## Technical Bulletin N°01

REFERENCE BT\_2017\_FR20\_01\_UK

SUBJECT 2017 User Manuals + new starter heatshield for FORMULA RENAULT 2.0

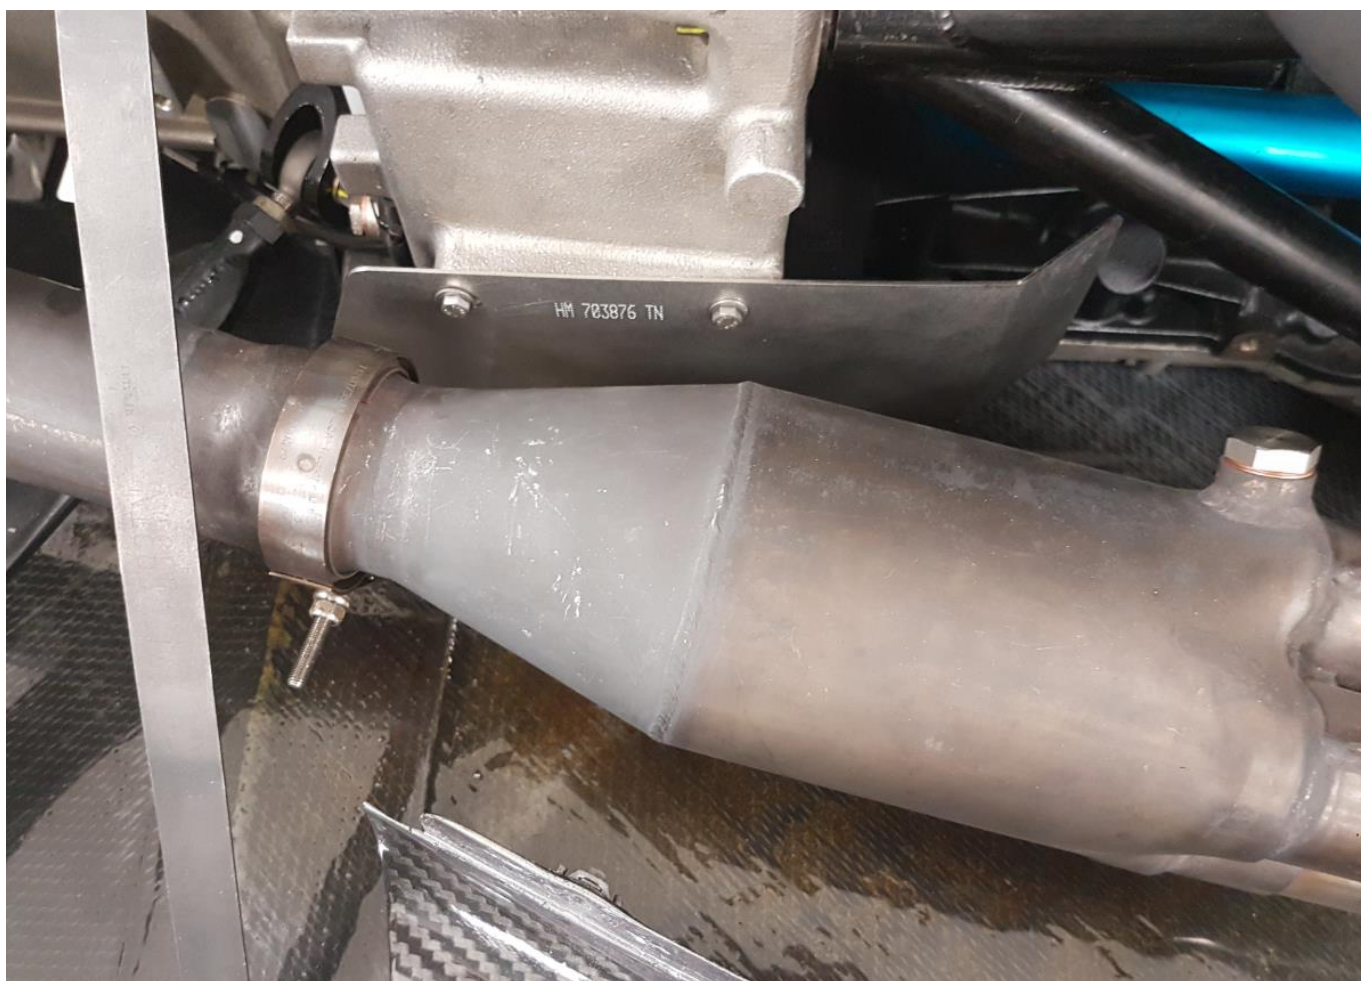
A - INTRODUCTION	2. CONTACTS : NEW PEOPLE AND ADDRESS 3.1. CAPACITIES: NEW ENGINE OIL 4.3.2. CLARIFICATION ABOUT MASTER SWITCHES
B - CHASSIS	2.9.9. UPRIGHT LOWER PINS ASSEMBLY (FOR OLD UPRIGHTS ONLY. REFERENCE: 77 11 166 201) REMOVAL OF THIS SECTION WITH OLD UPRIGHTS ASSEMBLY 8.3.1. 2016 OPTIONAL ECU FITTING BRACKET SET ON RADIATOR DUCT
C - ENGINE	2.3.2. LUBRICATION: TOTAL QUARTZ RACING 10W60 IS THE ONLY ENGINE OIL ALLOWED 4.1. WATER TEMPERATURE SENSOR: ADDING THE NEW FLYWIRE CONNECTOR SENSOR (77 11 166 957) 4.9. ENGINE OIL TEMPERATURE SENSOR: ADDING THE NEW FLYWIRE CONNECTOR SENSOR (77 11 166 957)
D - TRANSMISSION	5.3. MAINTENANCE OF THE GEARBOX: SADEV CONTACT UPDATE. 6.3.3. XAP SERVICING PROCEDURE AND CONTACT: XAP CONTACT UPDATE.
E - ELECTRONICS	7.9.7. BRAKE PRESSURE SENSORS: ADDING THE NEW REFERENCE FROM 2016
F - TYRES	1. INTRODUCTION: NEW MICHELIN CONTACT
